From: drainage <drainage@midsussex.gov.uk>
Sent: 27 June 2025 17:51:52 UTC+01:00
To: "Andrew Horrell" <Andrew.Horrell@midsussex.gov.uk>
Cc: "drainage" <drainage@midsussex.gov.uk>
Subject: 2025.06.27 Re: DM/25/0321 62 Leylands Road Burgess Hill West Sussex RH15 8AL

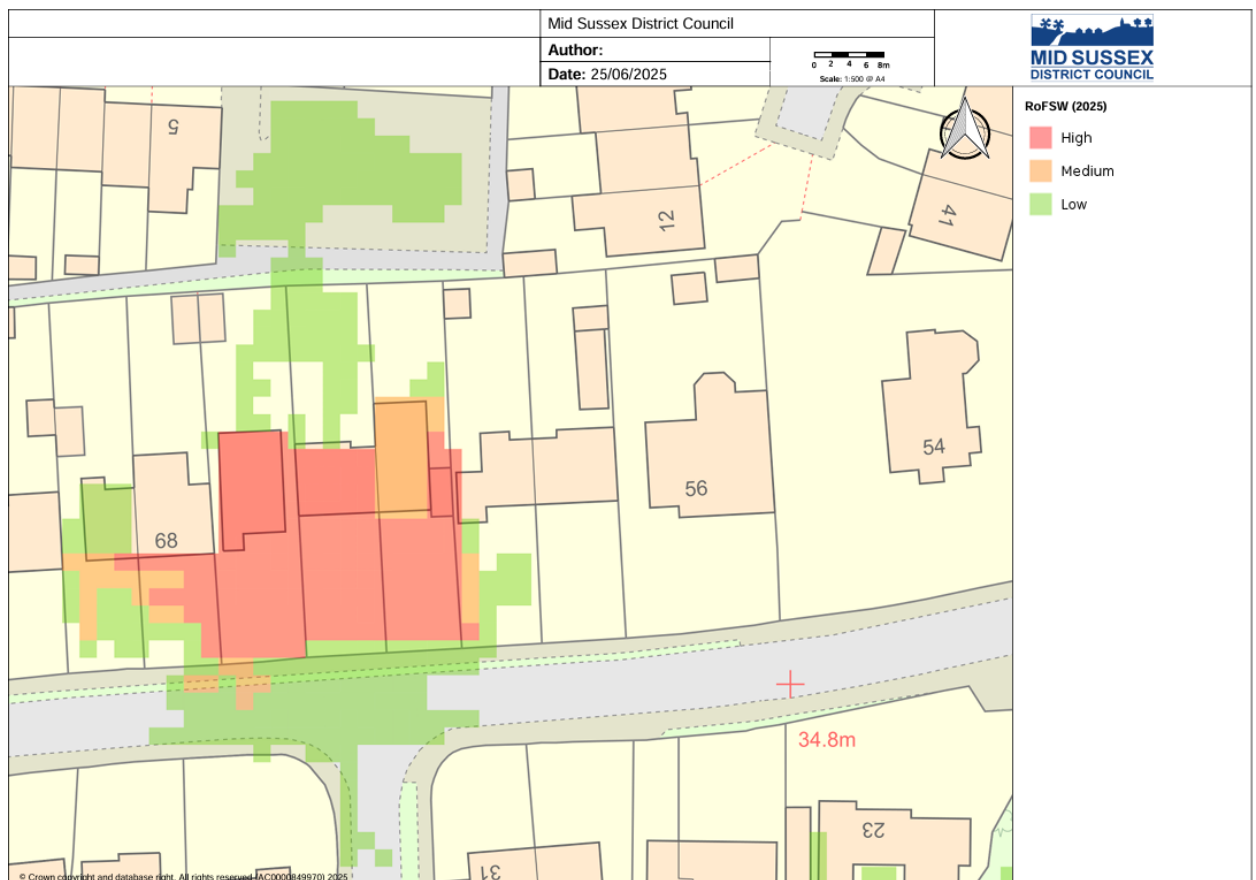
The updated Risk of Flooding from Surface Water mapping released in March 2025 shows the proposed development site is located within an area impacted by High, Medium and Low surface water flood risk. Following the approach set out under the NPPF for assessing fluvial flood risk (flood zones) this area would be considered consistent with Flood Zone 3b, 3a and 2.

As per the Environment Agency standing advice for minor extensions, development within the 1:30 (3b) flood extent is not permissible. In the event that the proposal is outside of this extent, then additional resistance and resilience mitigation will need to be evidenced at this location, as this development is classified as 'more vulnerable'.

In addition to a Flood Risk Assessment, we would advise that the applicant that an overlay of their proposed block plan on the above screenshot (or equivalent) of the 1:30 flood extent is required at this stage of planning in order for us to review any encroachment.
